Change of package and quantity per carton of CR-2477/BN

■ Model Number CR-2477/BN

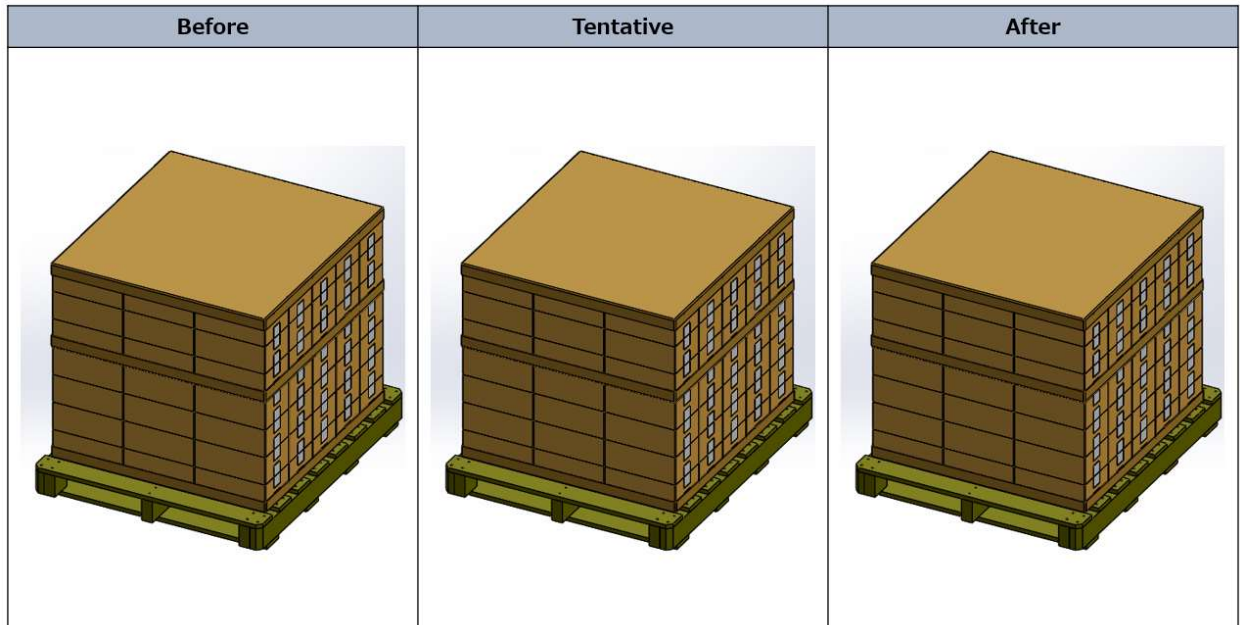
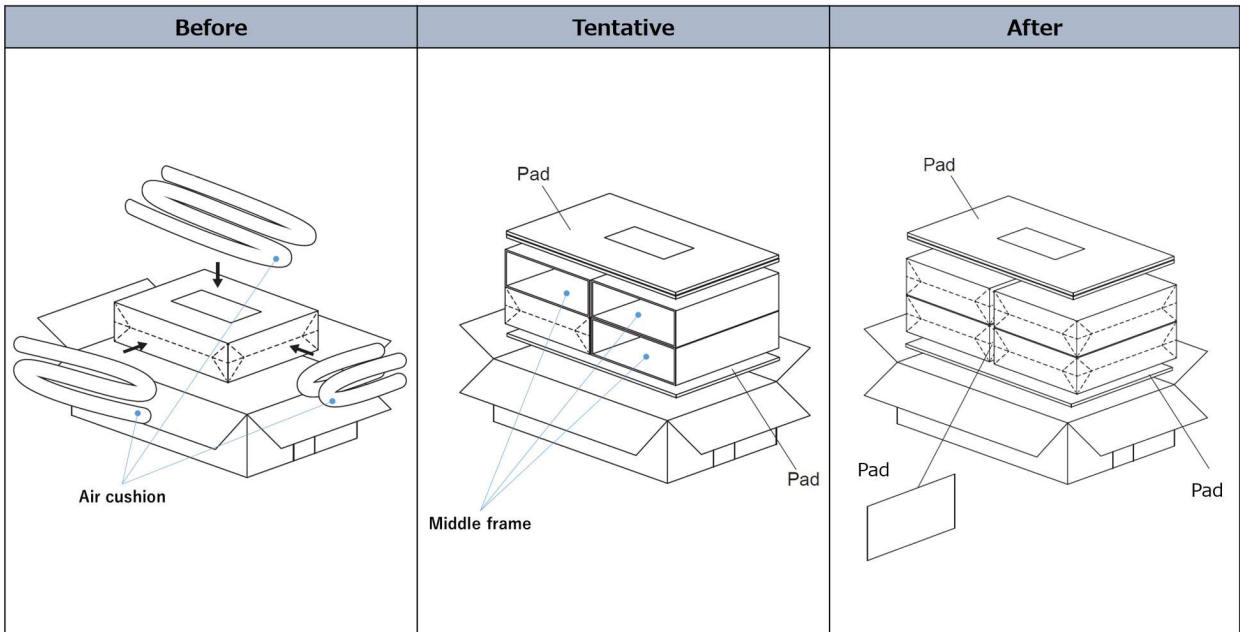
Panasonic found a minor problem after we made a drop test of CR-2477/BN internally based on UN 3090 criteria. Although Panasonic criteria is more severe than that of UN 3090 criteria, we decided to take an urgent countermeasure to strengthen shock absorption based on our quality policy. Also, we will increase the quantity per carton, responding to the request from some customers. Below is the overview of the change.

-November 100pcs/carton as temporary solution
 Carton materials are used instead of air pillows

-December onwards 400pcs/carton
